## Statement by Melissa Macfarlane regarding my submission on PC13/PC14 impacting on 48 Malvern Street, St Albans, Christchurch

29<sup>th</sup> November 2023

48 Malvern Street (page 183)

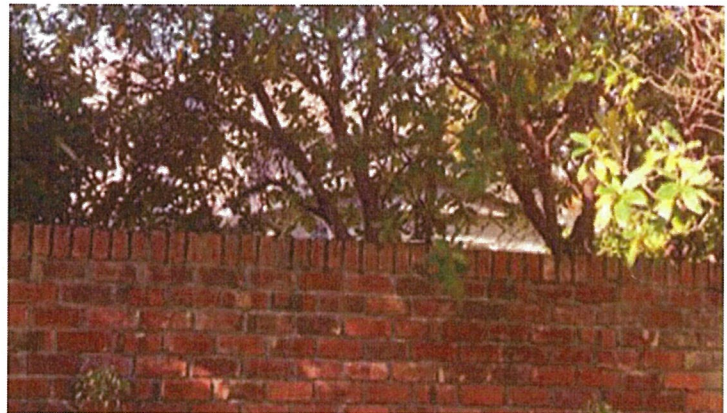
It has the ground floor extension noted but not the upper floor/rear extension.

Our house has no bay windows in the front, no sunhoods and the only original fanlight fenestrations are in the one remaining box window down the righthand side on the West boundary and a small bathroom window at the back on the Eastern boundary.

Our windows are not typical, and we have several sets of French doors and the large 'picture' window in the front extension circa 1960s which while complimentary is not original.

The entrance is in the front not on the side and we breach the recommended height limit set to protect the character of the area. We have a concrete garage and tall brick fence.
